Model	DJF for F400 / 410	Volt/Hz	Date of Modification	Serial Number
Modified Article	Parts Catalog			
Reason for Modification	Parts catalog correction

Model	DJF for F400/410	Volt/Hz	Date of Modification	Serial Number
Modified Article	Feed Roller Guide and Holder - Feed Roller Guide			
Reason for Modification	To prevent the original multiple feeding

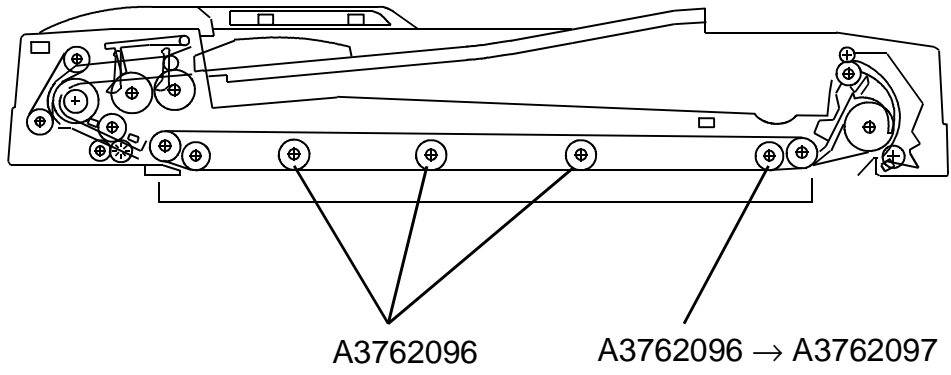
To improve the small size original transportation, one of four belt pressure roller is modified.
 (The diameter is increased from 20mm to 24mm to apply more pressure.)

Old P/N	New P/N	Description	Q'ty Used	Inter-changeability	Parts Catalog	
					Index No.	Page
A37362096	A3762096	Belt Pressure Roller	4 → 3	—	11	13
	A3762097	Belt Pressure Roller - Large	0 → 1	X/O	* 22	13

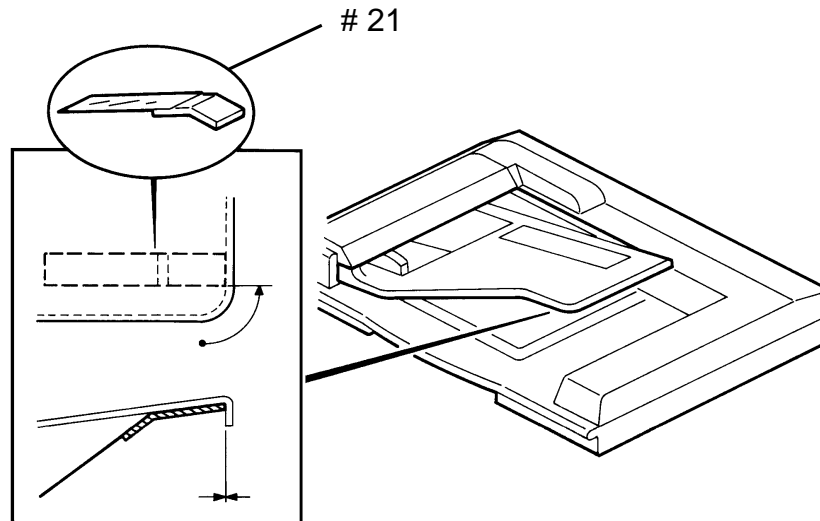
To ensure original stack in auto counting mode, the original exit guide mylar has been added as shown. For details please refer to F400 RTB - 033.

P/N	Description	Q'ty Used	Parts Catalog	
			Index No.	Page
A3764577	Original Exit Guide Mylar	0 → 1	* 21	5

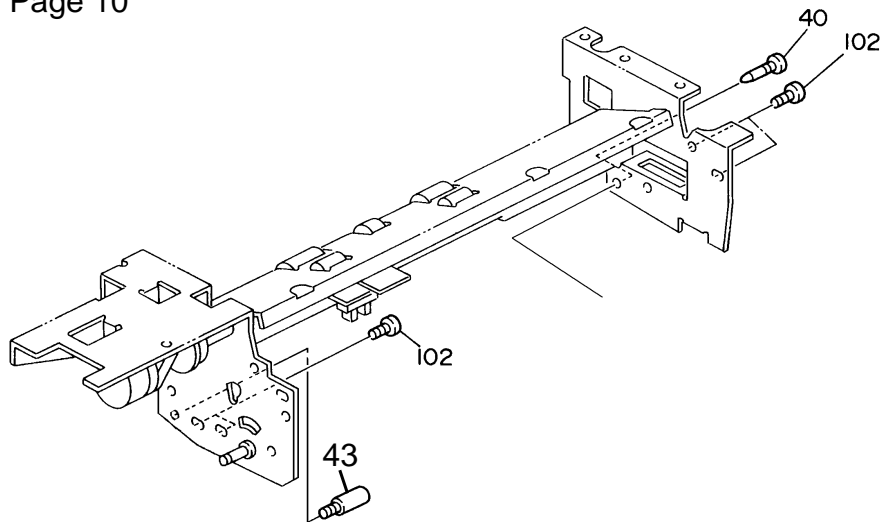
Please correct your parts catalog as follows:
Please add following parts.

New P/N	Description	Q'ty Used	Parts Catalog	
			Index No.	Page
54221737	Shaft	1	* 43	9

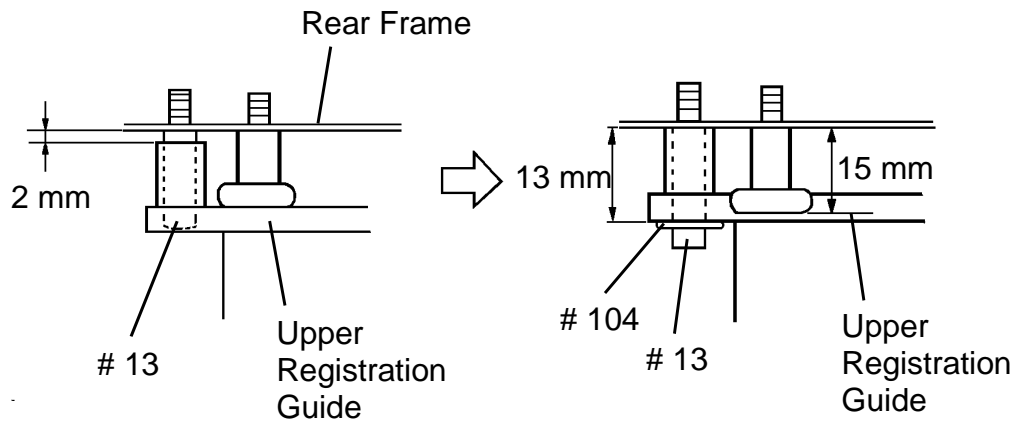
The upper registration guide contracts under a low temperature condition, and the side play of the guide becomes wider. This allows the guide to turn over the stopper in some cases. To prevent this by limiting the side play of the guide, the shaft has been changed in shape and a retaining ring has been added.

Old P/N	New P/N	Description	Q'ty Used	Inter-change-ability	Parts Catalog	
					Index No.	Page
A4693350		Guide Stud	1 → 0	X/O	13	9
	C2175524	Stud - Front Release Lever	0 → 1			
	07200040B	Retaining Ring - M4	n → n+1		103	9

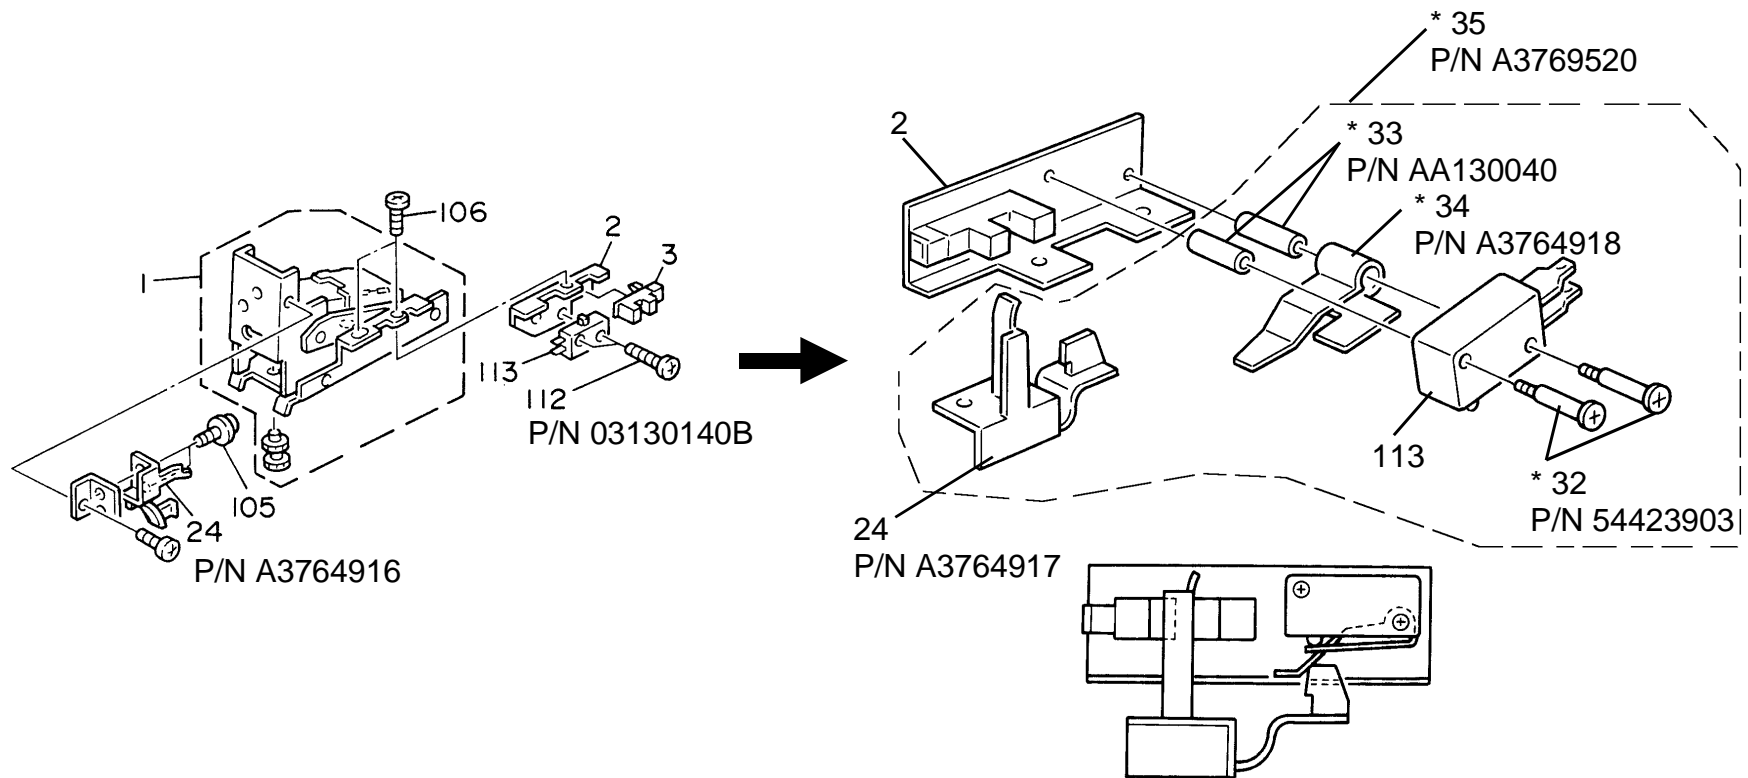
To prevent the reset switch lever (Index No. 24) from being broken, a spring plate (P/N A3764918) which works as a cushion has been added as shown.

When the old lever (P/N A3764916) is broken, please install the new parts as a set, because the old one will not be supplied as a service part. The set part number is A3769520.

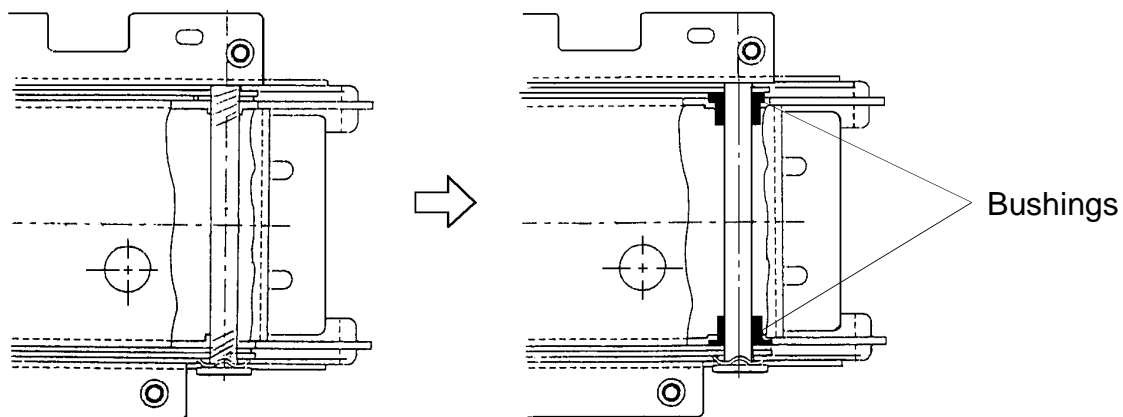
To increase the durability of the left and right hinges, two bushings have been added as shown below.

Old P/N	New P/N	Description	Q'ty Used	Inter-changeability	Parts Catalog	
					Index No.	Page
A3764160	A3764159	Left Hinge	1 → 1	X/O	1	17
A3764190	A3764189	Right Hinge	1 → 1	X/O	5	17

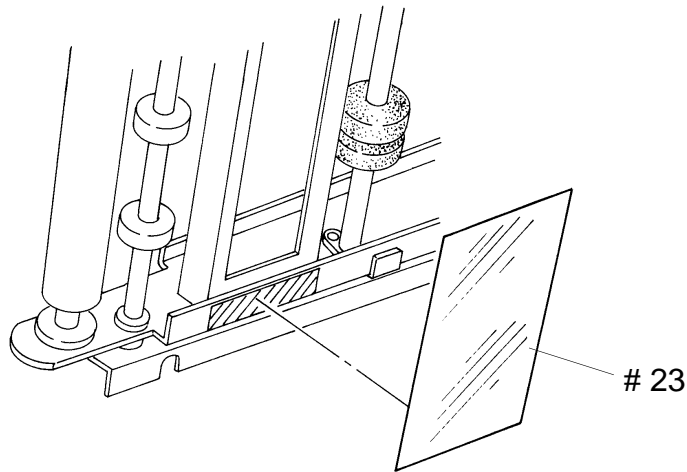
To prevent the transport belt going behind the rear transport frame and being pressed by book originals when the DJF is closed, the guide mylar has been added.

New P/N	Description	Q'ty Used	Inter-change-ability	Parts Catalog	
				Index No.	Page
A3761252	Feed Roller Guide	0 → 1	—	* 23	13

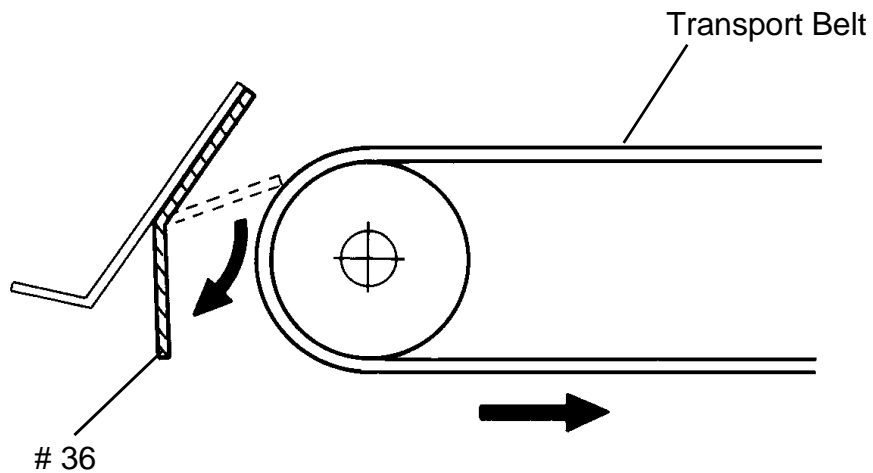
New material (urethane) has been employed for the separation guide mylar. The new mylar always resets to the correct position as the transport belt turns due to its softness, even if the mylar is bent up when installing the transport belt.

Draw No.	Old Parts No.	New Parts No.	Description	Rank	Q'ty Used Old→New	Inter-changeability	Parts needed for replacement by new part		Parts Catalog	
							Part No.	Description	No.	Page
	A3761187	A3761190	Separation Guide Mylar	C	1 → 1	X/O			36	11

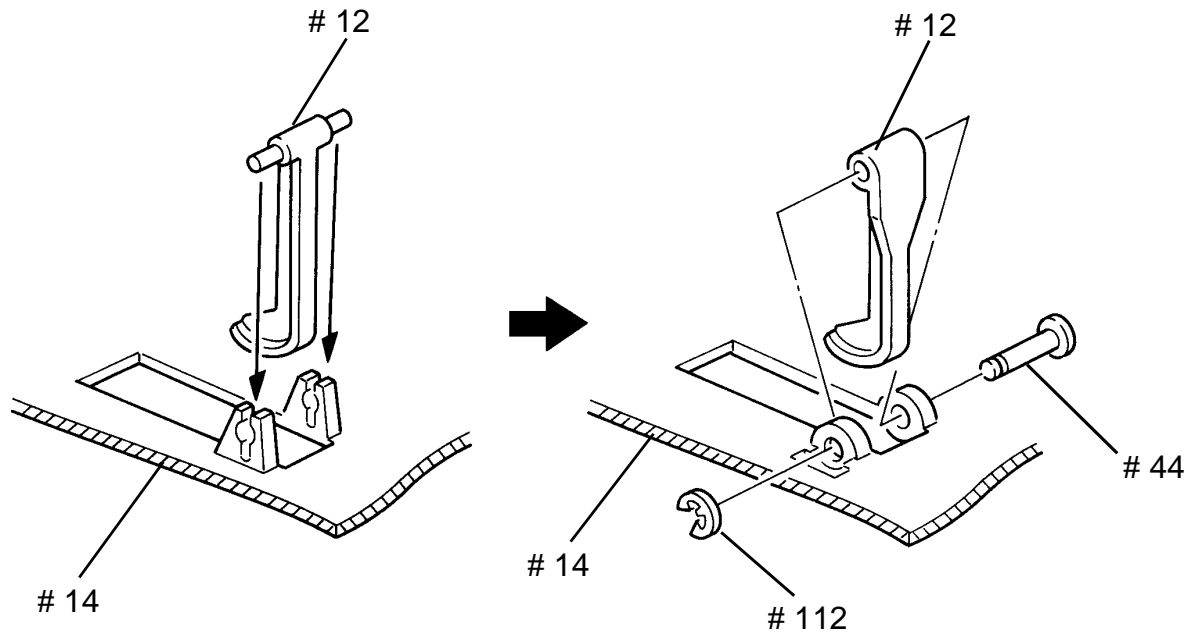
To prevent the feelers for the original set and feed sensors from popping off during the operation by a customer, the mounting design has been changed from a snap-in type to a pin-fix type as shown below.

The old type sensor feeler is no longer available because the mold had been changed for the new type. Therefore, please install all the new type parts as a set when the old type feeler needs to be replaced. This action is also recommended to prevent the above problem.

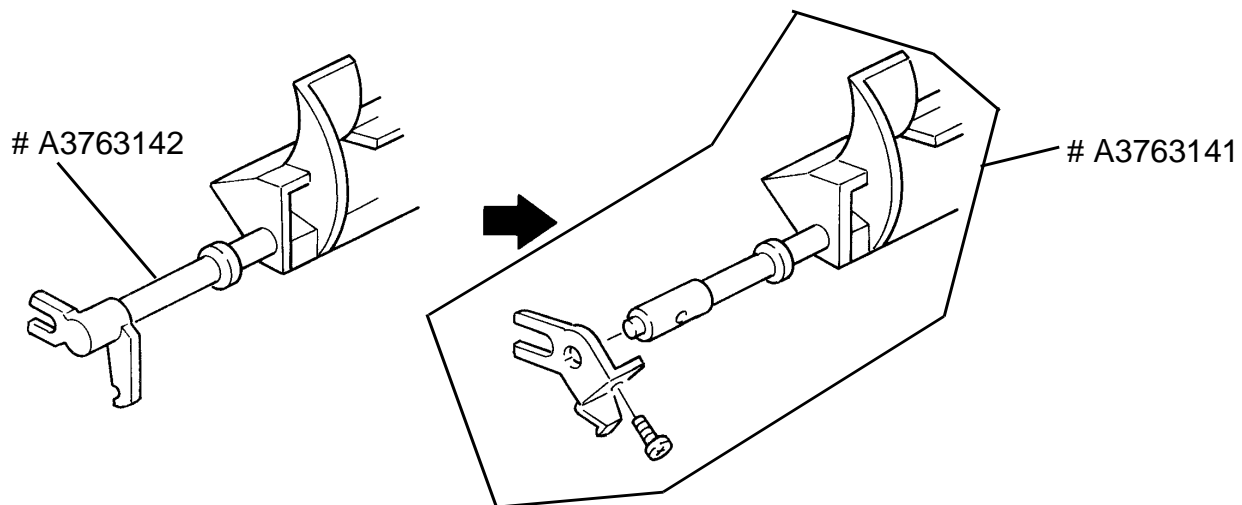
The following part has been changed for part standardization purposes.

Old P/N	New P/N	Description	Q'ty Used	Inter-changeability	Parts Catalog	
					Index No.	Page
A3763142	A3763141	Inverter Pawl	1 → 1	O/O	6	15

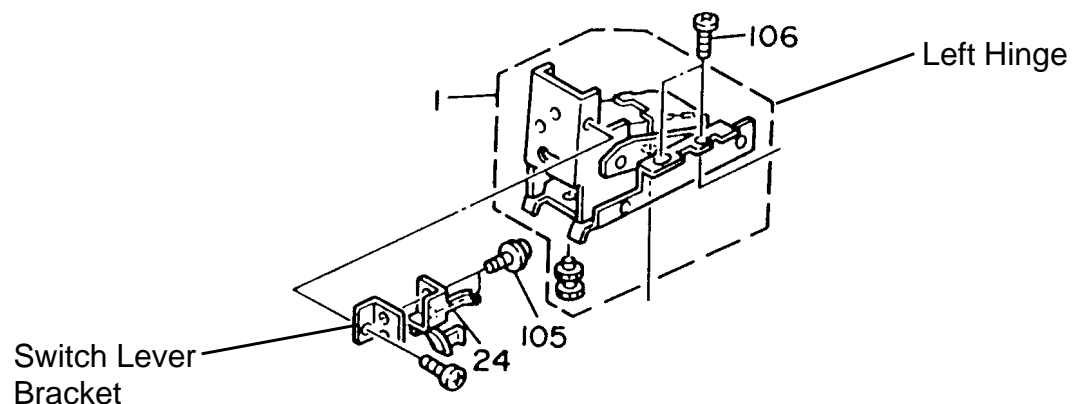
The switch lever bracket, which is originally included in the left hinge, has become available as an independent service part.

New P/N	Description	Q'ty Used	Parts Catalog	
			Index No.	Page
A3764151	Switch Lever Bracket	0 → 1	* 36	17

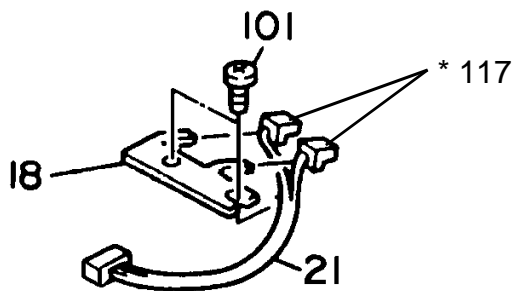
Please add the following to your parts catalog.

New P/N	Description	Q'ty Used	Parts Catalog	
			Index No.	Page
14030493	LED - Green	0 → n	* 117	17

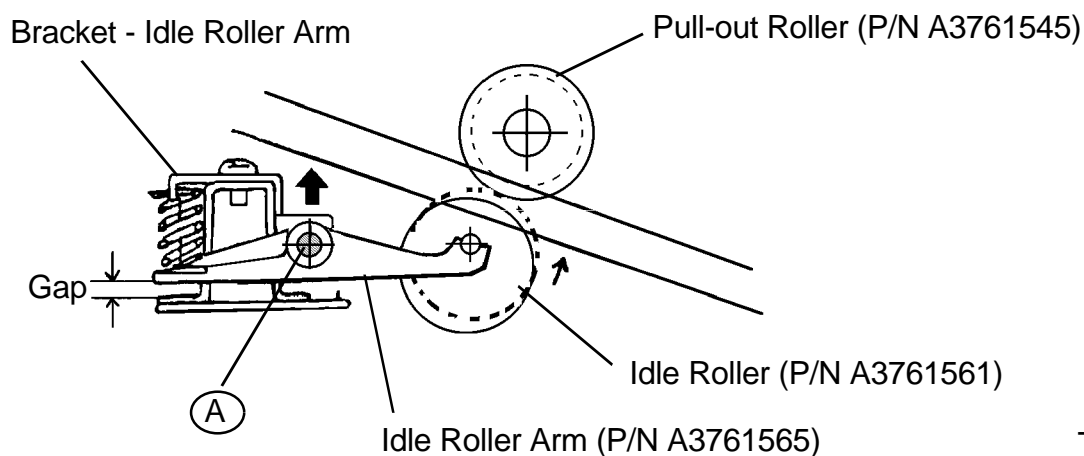
Over time, wear on the pull-out roller leads to a decrease in pressure (as well as a reduction in the gap) and may result in original jams or incorrect size detection.

To prevent this, the position of the stud (A) in the bracket-idle roller arm has been raised by 1 mm to maintain the pressure.
